Report No:	Date:
FCL/644/SW02	20 May 2024
Project:	
Tydd Solar Guanock Farm, Sutton St Edmund Lincolnshire, PE12 0LW Addendum to the Surface Water Management Plan	
Client:	
PACE Titan Energy Limited

<i>Project Title</i>	Tydd Solar Renewable Energy Facility, Guanock Farm, Sutton St Edmund, Lincolnshire, PE12 0LW (UKZ 157)
<i>Report Title</i>	Surface Water Management Plan - Addendum
<i>Revision</i>	A
<i>Status</i>	Issue 1
<i>Control Date</i>	20 May 2024
<i>Authorised for Issue</i>	Faruk Pekbeken, BEng CEng MICE Technical Director

Figure 5: Proposed Swales and SW Exceedence Routes Plan

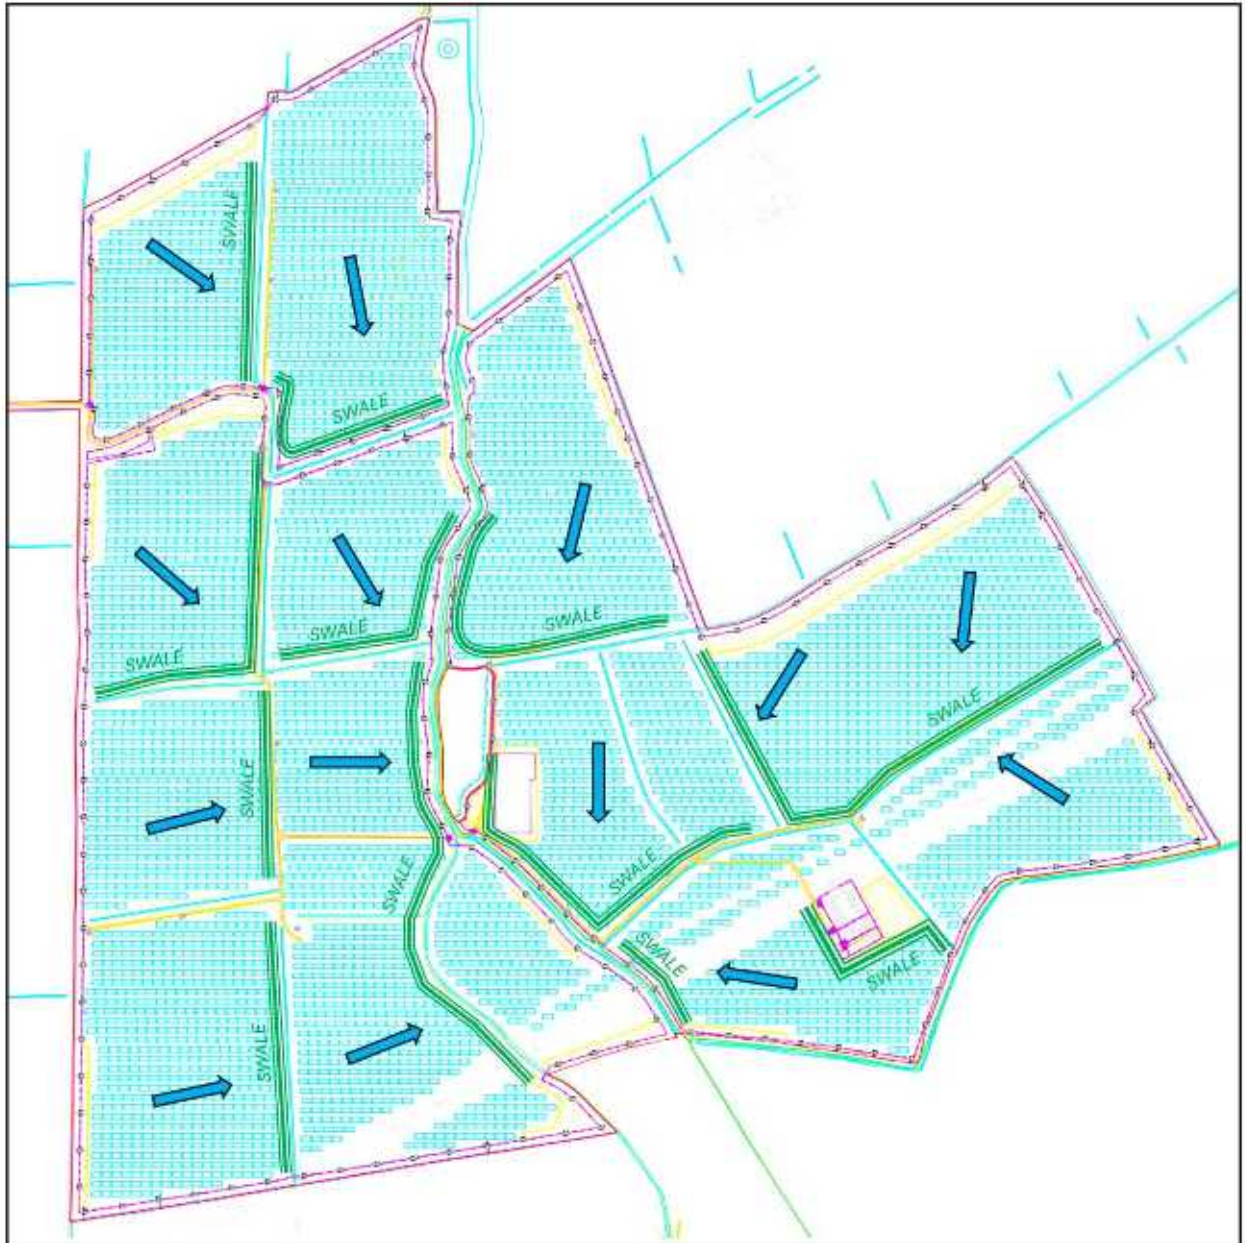
Whilst it is broadly accepted that solar farms do not respond in the same way as impermeable surfaces, they can lead to localised channelling of rainfall, particularly on sloping sites. This has the potential to increase flood risk downstream.

Options such as the inclusion of a French drains at the base of each row/ along access tracks to intercept flows and address water quality, inclusion of a swale(s) at the lowest parts of the site and designing panels with horizontal slots across the surface area should be considered as measures to manage surface water.

An extensive network of swales is proposed at Tydd Solar Farm as shown in **Figure 5** below totalling approximately 3,600m. The swales extend along the lower boundaries of individual fields to intercept exceedence flow routes into existing ditches, drains and watercourses.

The existing and proposed SW exceedence flow routes remain the same as there is no requirement to alter the existing topography as a result of the panel installation. The new swales are easily accessible for future maintenance by Pace personnel.
